LOEHMANN'S PLAZA

PRELIMINARY PLAN NO. 120240100

SITE PLAN NO. 820240120 (PHASE I)

FOREST CONSERVATION PLAN NO. F20240680

Figure 10: Proposed Common and Public Open Space – Future Phase II

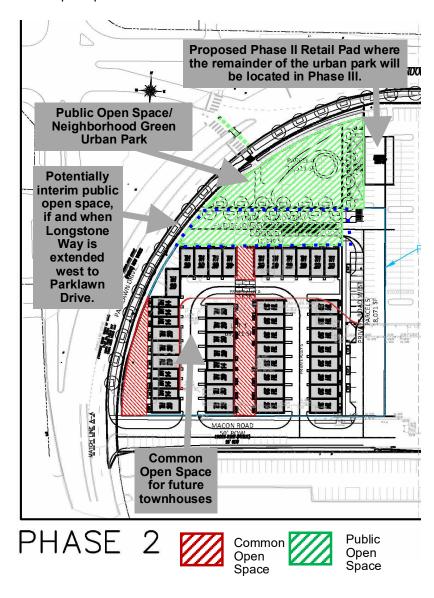
- j) Revise the public benefit table to reflect that transit proximity points are for Level 2 category.
- k) Update the Phase II boundary on the Open Space Exhibit to match the overall Phasing Plan and clarify that the future 3,000 square foot pad site is included in Phase II.

Figure 14: Proposed Randolph Road Cross-Section

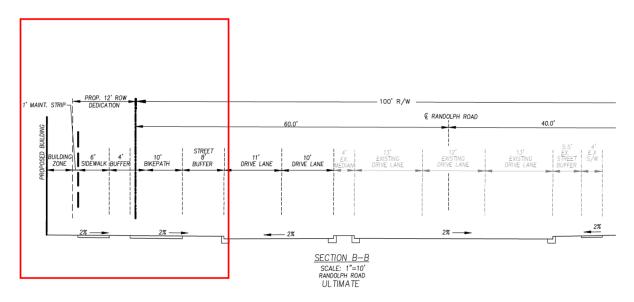
- e) Update the plans to show the removal of the existing utility poles.
 - f) On Randolph Road, remove the reduction of the street buffer around the existing utility poles and the transition of the bike lanes around the utility poles. The bike lane facility should be straightened, and a consistent street buffer of 8 feet should be shown.

- g) Remove the Randolph Road cross-section that shows the condition adjacent to the existing utility poles.
- h) Provide a loading management plan that includes the quantity and location of the required roadway signage for truck size restrictions for the Site.

Figure 17: Proposed Lauderdale Drive Cross-Section

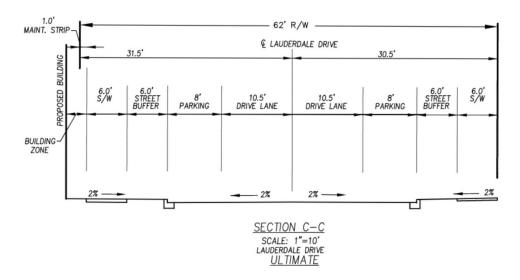
- g) Revise the proposed road cross-sections as follows:
 - i. Eliminate on-street parking on Lauderdale Drive immediately south of the intersection with Randolph Road.

- ii. Update the Lauderdale Drive Street Section K-K to reflect the removal of on-street parking. The space shown as on-street parking must be modified to provide both a wider street buffer and southbound travel lane.

- iii. Update the south leg of the Lauderdale Drive and Randolph Road intersection to show the existing median being cut back to the south to remove conflicts with truck turning templates for an SU-30 vehicle.
